WICHITA - SEDGWICK COUNTY

Re: Preliminary Plat S/D 88-40 - CHAPMAN'S REPLAT

STAFF REPORT  
(Preliminary Plat)

CASE NUMBER: S/D 88-40 - CHAPMAN'S REPLAT  
OWNER/APPLICANT: Patrick Chapman, 1601 N. Woodlawn, Wichita, KS 67208  
SURVEYOR/ENGINEER: Dobler Surveying and Engineering  
LOCATION: Southeast corner of 13th and Market.  
SITE SIZE: 0.24 Acre  
NUMBER OF LOTS:  
Residential:  
Office:  
Commercial: 1  
Industrial:  
Total: 1  
MINIMUM LOT AREA: 0.24 Acre  
CURRENT ZONING: "B"  
PROPOSED ZONING: "LC" (Z-2891)

# SITE PLAN

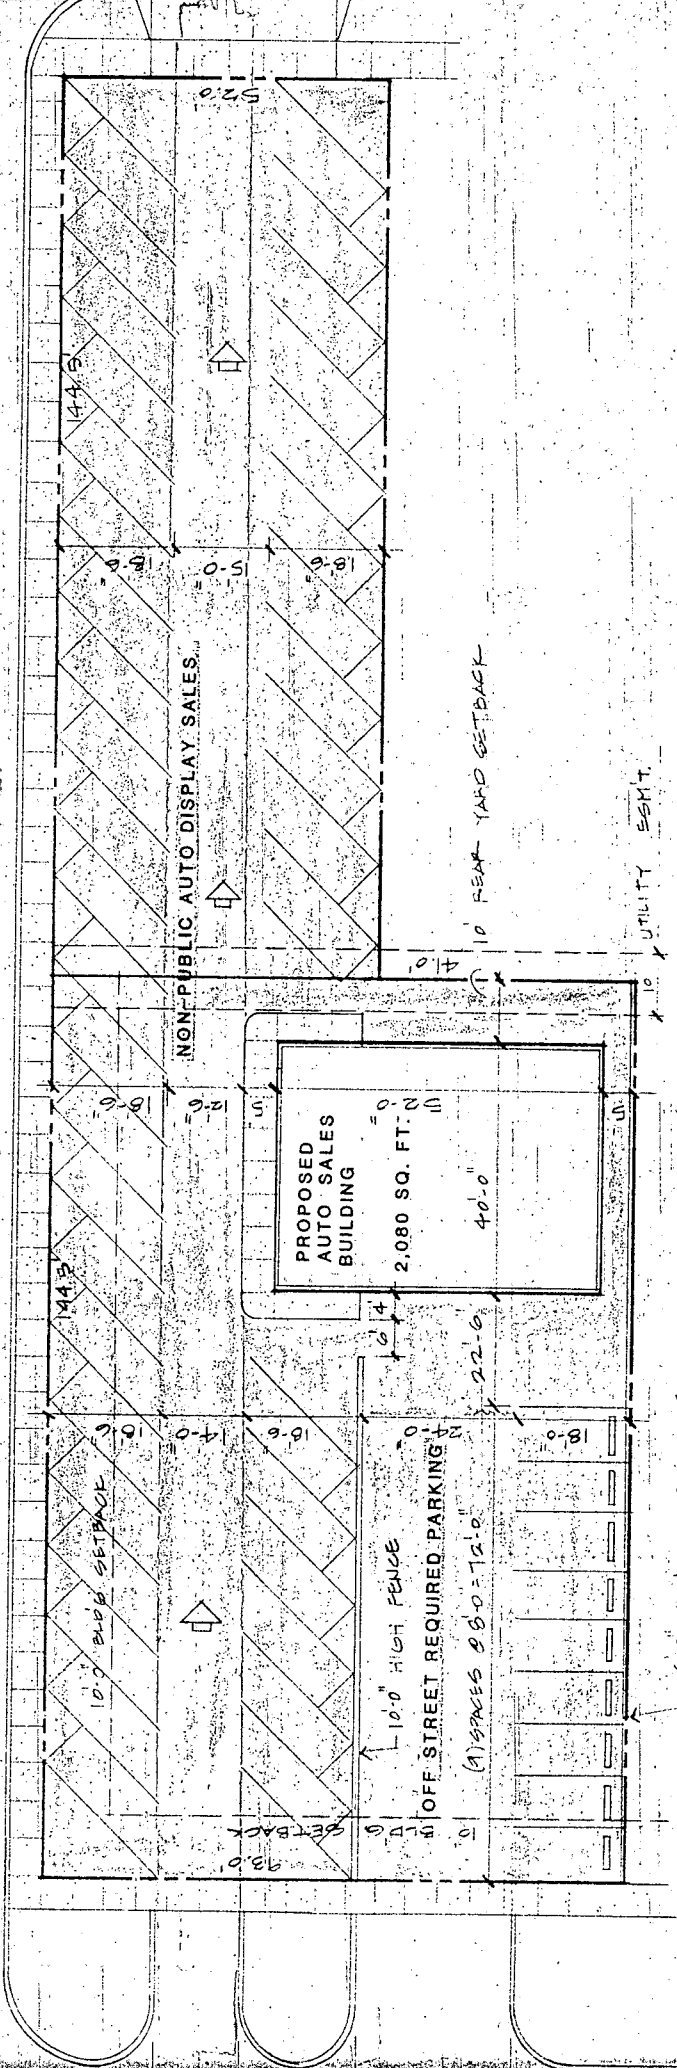
- A. The final plat shall indicate a 20-foot wide utility easement to cover the existing east/west sanitary sewer lateral on this property or the applicant shall guarantee the abandonment of this sewer line.

- C. The applicant is advised that the residential width drive to Market should be either closed or reconstructed to the commercial-width standard.
- D. Complete access control shall be indicated to both Market and 13th Streets for a distance of 40 feet back from the northwest corner of the lot.

- E. The final plat shall indicate a 35-foot building setback to Market.
- F. The final plat shall indicate a 10-foot utility easement adjacent to the east line of the plat.

- G. The final plat tracing shall indicate angles or bearings for the perimeter of this plat.
- H. The final plat shall clearly indicate the 20 feet of right-of-way being dedicated by this plat as well as the existing 30 feet of right-of-way for 13th Street.

- K. The existing structures which occupy a portion of the right-of-way being dedicated for 13th Street shall be removed prior to submitting this plat for scheduling before the City Council. Once the structures have been removed, the applicant's surveyor shall submit a letter so stating for the plat file.
